6/6/2025, 11:56:09 AM
BC-ALT-25-0059
Dylan Calella

Bertini/Palmerick ~ Longboat Key Towers
601 Longboat Club Drive, #702S
Sarasota, FL 34228

Kitchen and Bath Plan View

ELECTRICAL FLOOR PLAN
3/16" = 1'

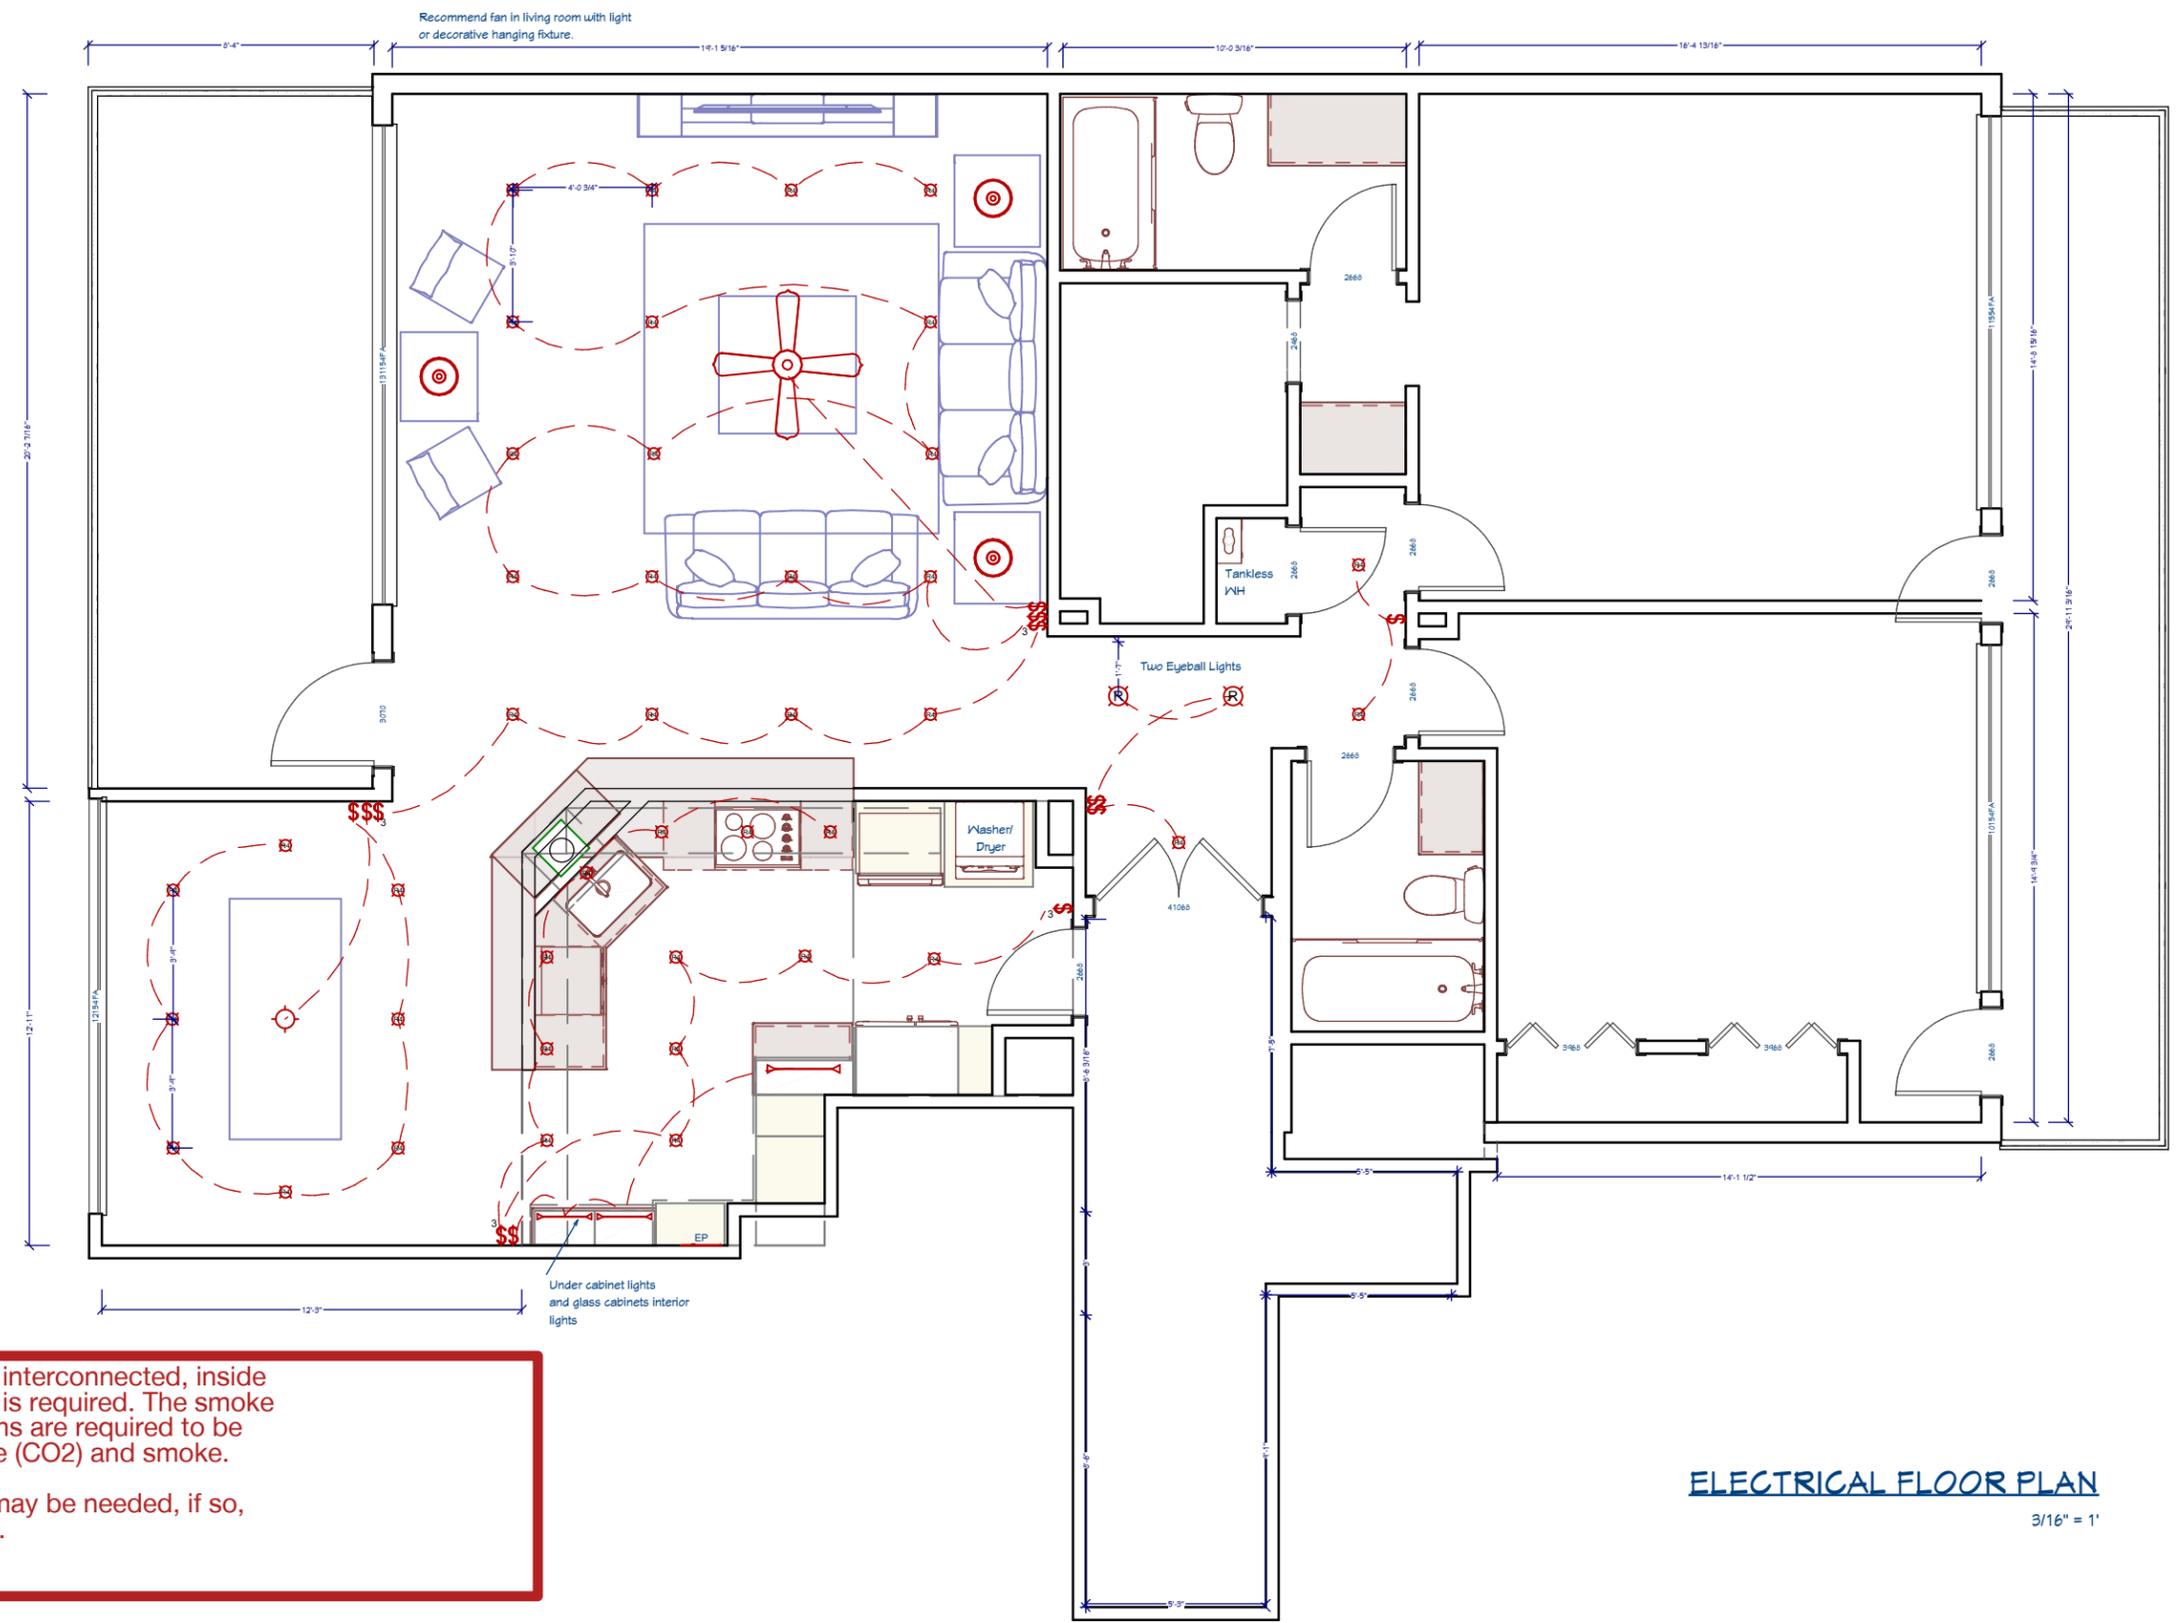
1. Smoke alarms, hard-wired, interconnected, inside and outside of each bedroom is required. The smoke alarms outside of the bedrooms are required to be combination carbon monoxide (CO2) and smoke.
2. Fire sprinkler modification may be needed, if so, prior approval will be required.
